May 20, 1996
Project 20H93-001.006

Re: (File No. 95-066), Response to RWQCB February 13, 1996, Review Letter
Dial Main Facility, 9300 Rayo Avenue, South Gate.

THE DIAL CORPORATION
MAIN FACILITY
9300 RAYO AVENUE
SOUTH GATE, CALIFORNIA

SITE PLAN

DRAWING NO.
1
PROJECT NO.
22493-001.007

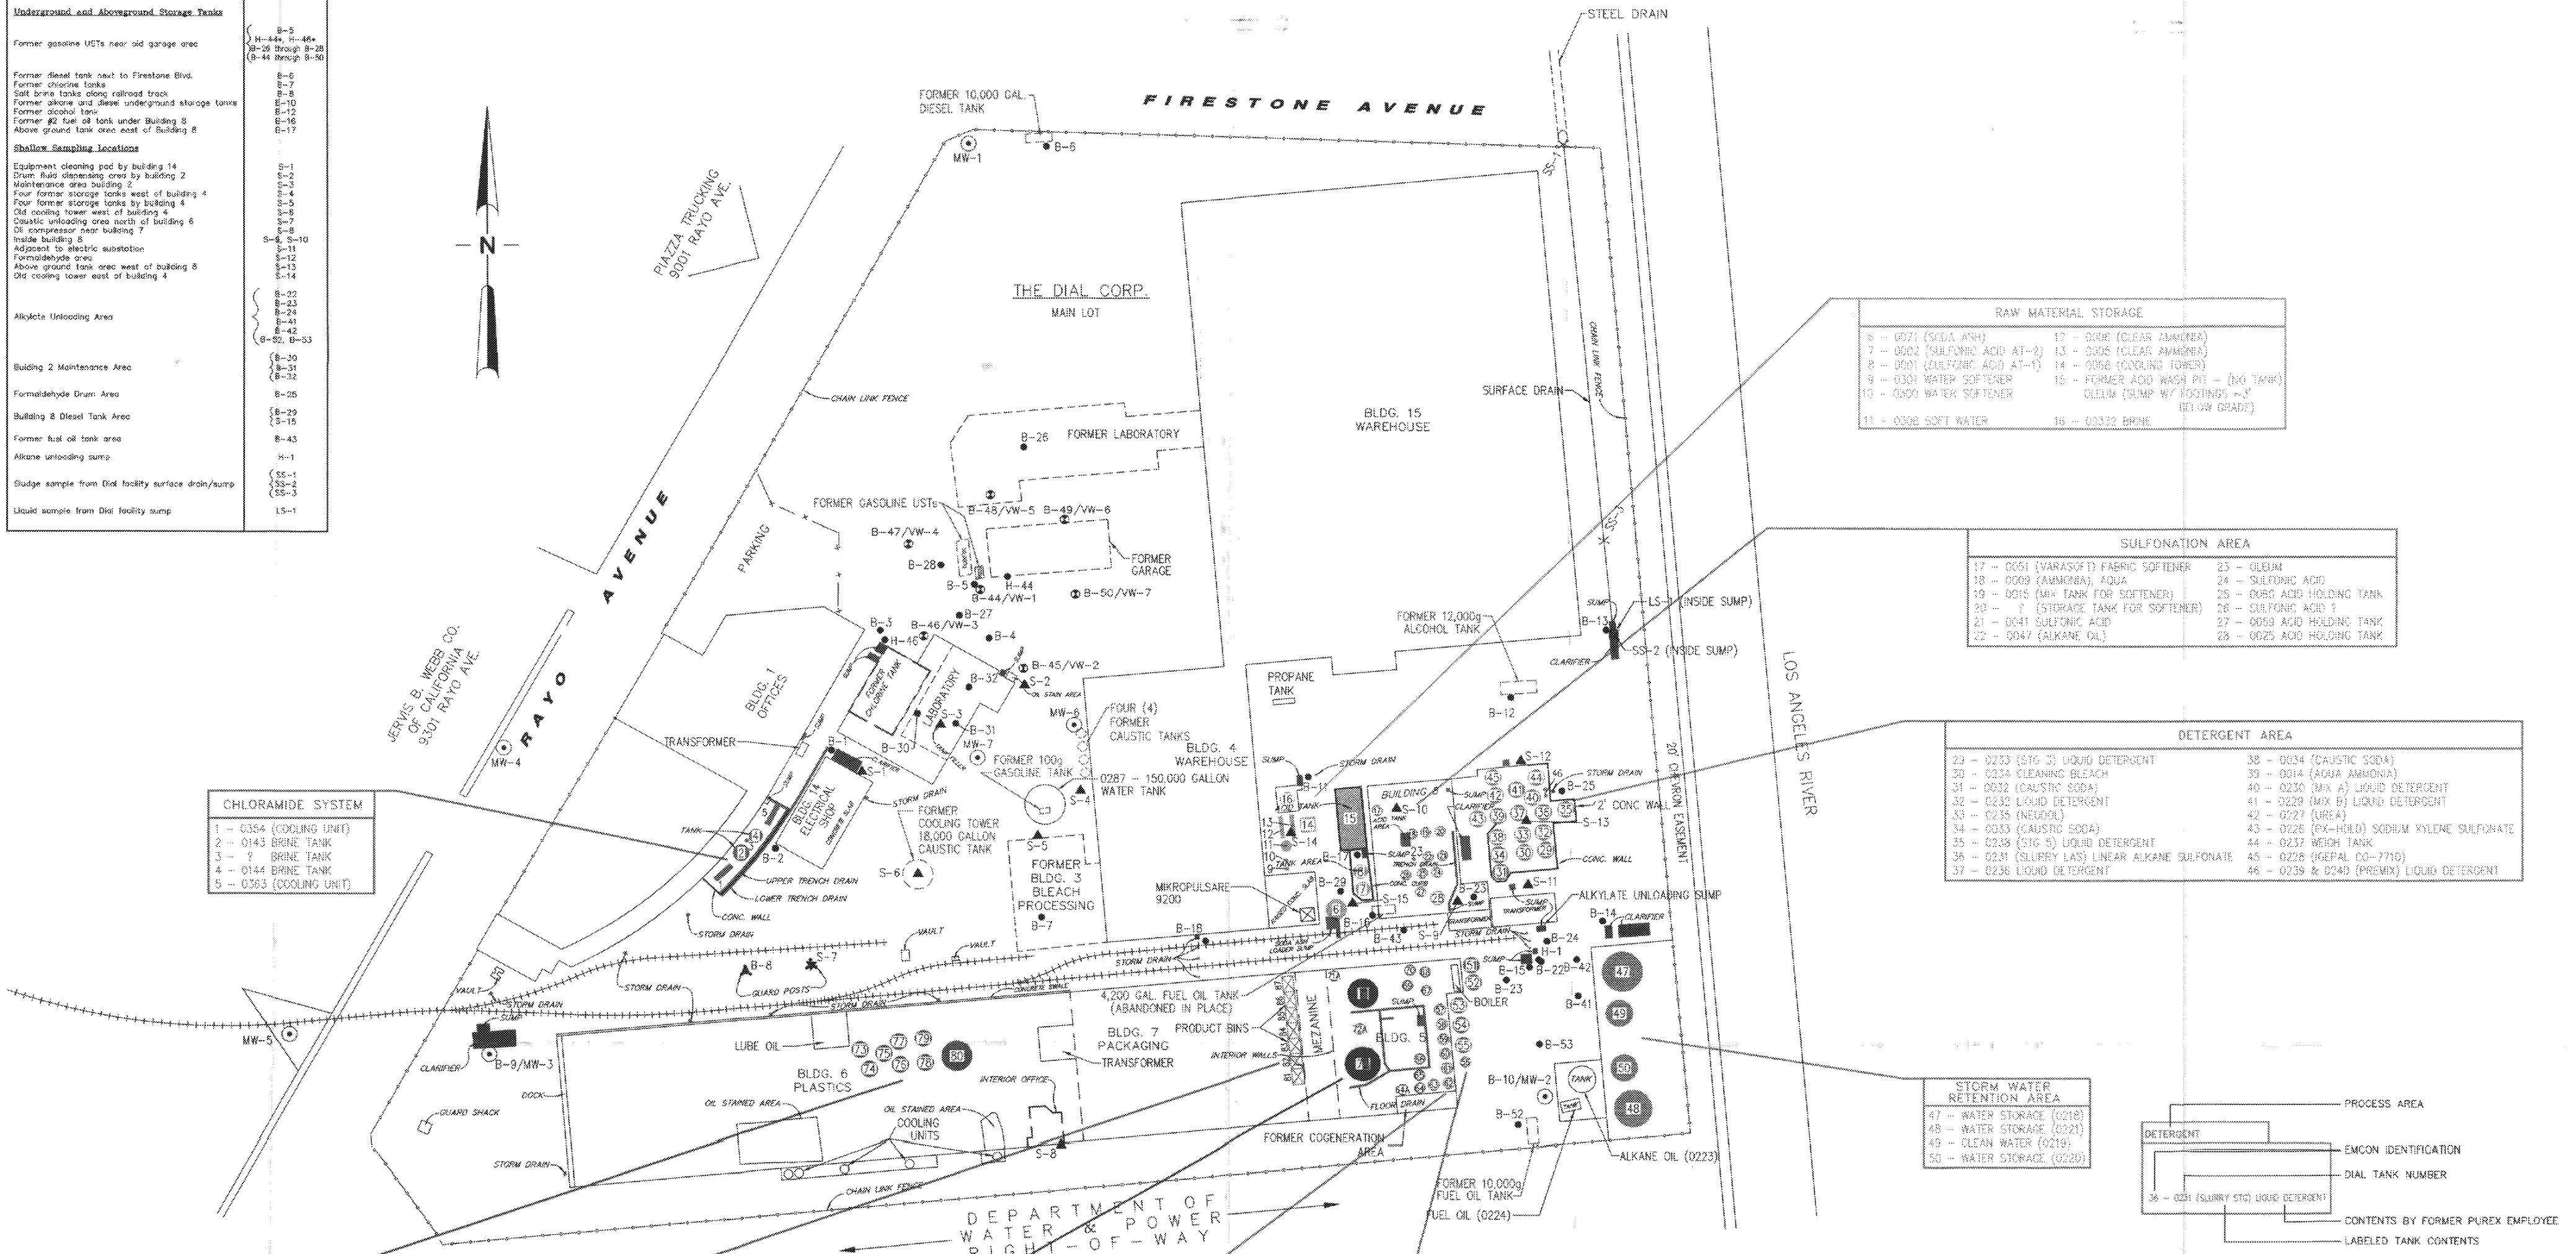
1. *During a site visit on December 6, 1995, staff noted that a number of sumps and equipment mounting pads inside several buildings have not been identified. We will require that all potential sources of contamination such as floor drains, sumps, and equipment pads be identified and its locations surveyed before the facility is decommissioned.*

9. The purpose of B-8 is to assess the impact of the salt brine tanks, located along the railroad tracks. Drawing No. 1 shows that the salt brine tanks are located between Building 1 and Building 14, and are approximately 60 feet away from B-8. Please clarify this discrepancy.

10. The following items are not shown on the recently submitted drawing:

- Two clarifiers related to B-9.*
- Oil compressor related to Sample S-8, near Building 7.*
- Former Chlorine Tank in Building 3.*

Site demolition operations commenced during the week of April 8, 1996. Surveying of structures as requested by the RWQCB was completed that week and the information is shown on Drawing 1, which was submitted at the May 8, 1996 meeting.

Recent investigation, shows boring B-8 was probably next to a caustic unloading area similar to where sample S-7 was collected (see recent surveyed map). The sampling scheme for boring B-8 was the same as surface sample S-7 and included analysis for phosphate and chlorides.

The two clarifiers related to boring B-9 are the same as those adjacent to well MW-3. Boring B-9 was the pilot boring for well MW-3 (Drawing 1).

The former chlorine tank, effectively encompassed the entire footprint of Building 3 (Drawing 1).
